November 17, 2010

Mr. Greg Solomon Senior Air Quality Engineer Bay Area Air Quality Management District 939 Ellis Street San Francisco, CA 94109

Response to BAAQMD Letter, dated October 6, 2010 Request for Renewal of Chevron Energy & Hydrogen Renewal Project Authority to Construct – District Regulation 2-1-407 Application No. 12842, Plant 10 PECENTUS RECEIPED

Hydrogen Plant Reformer Furnaces (S-4471/S-4472) & Hydrogen Recovery Unit (S-4451)

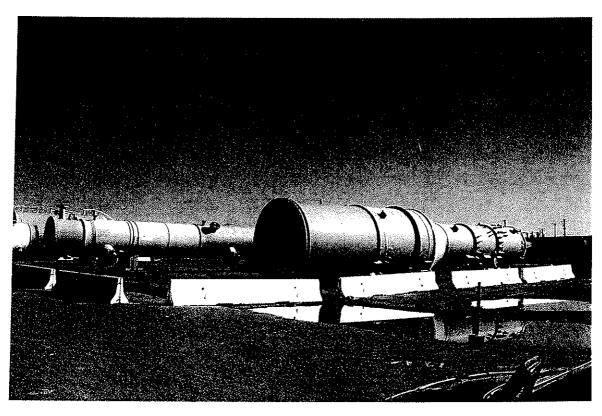
For all sources contained in Attachment 3 of your letter that are claiming substantial use, please provide information that demonstrates Substantial Use per Regulation 2-1-227.

The District issued the Renewal Project ATC on September 19, 2008. The project progressed until September 2009 when the Environmental Impact Report (EIR) appeal litigation forced construction to cease. Substantial contracting, mobilization, equipment procurement and construction took place during this time. The procurement and construction work completed for eight units listed below meets the Regulation 2-1-227 substantial use definition. Photographs are provided in Attachment 2 documenting that "purchase or acquisition of the equipment that constitutes the source" have taken place for those sources.
